Questions: 15/4

SOURCE: Rapporteur Q15/4\*

TITLE: M.3100 SERIES - TMN IMPLEMENTORS' GUIDE - DEFECTS AND RESOLUTIONS;  
VERSION 8 (18/08/2000)

A13 DR-M3100-39 (\*)

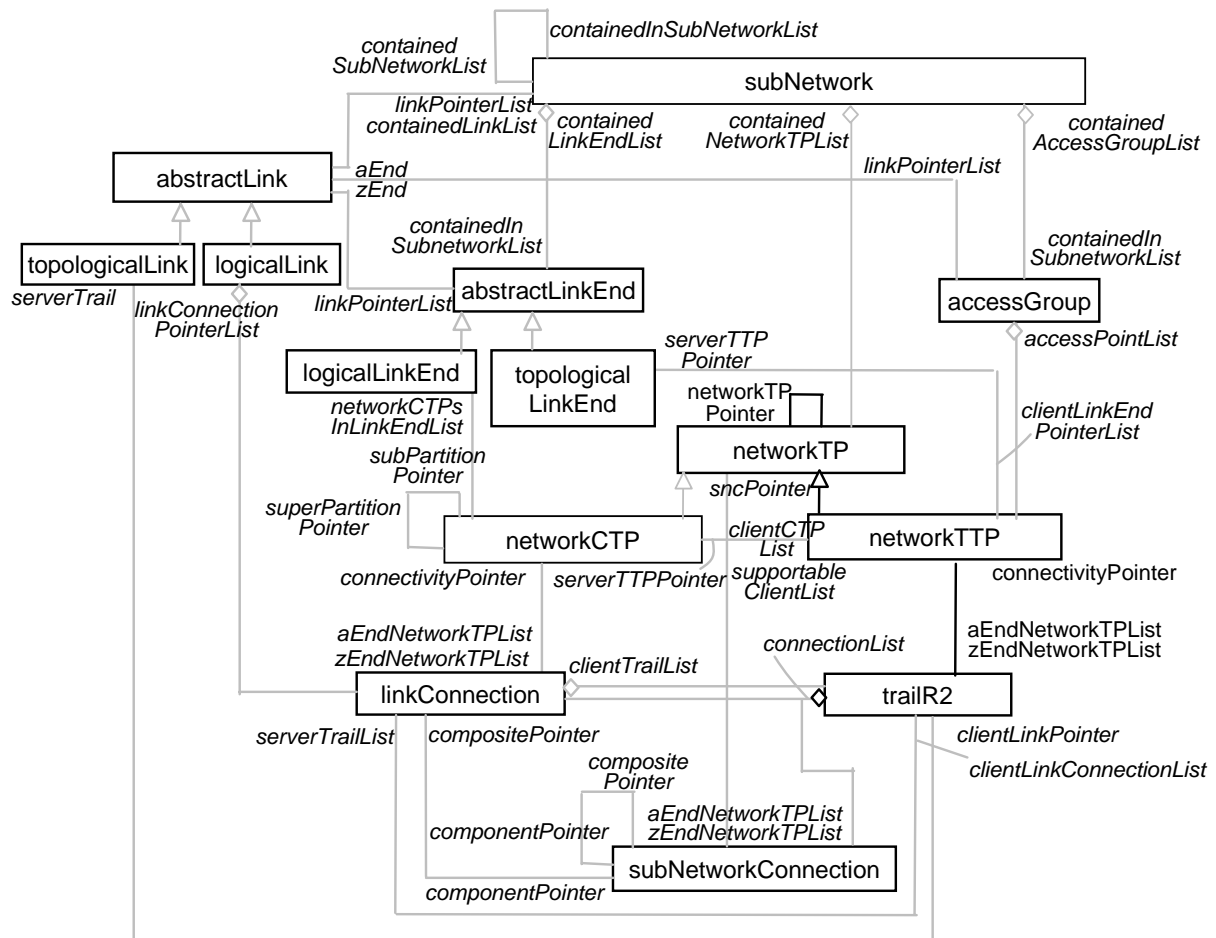
In section x.x, add the following revised E/R Diagram
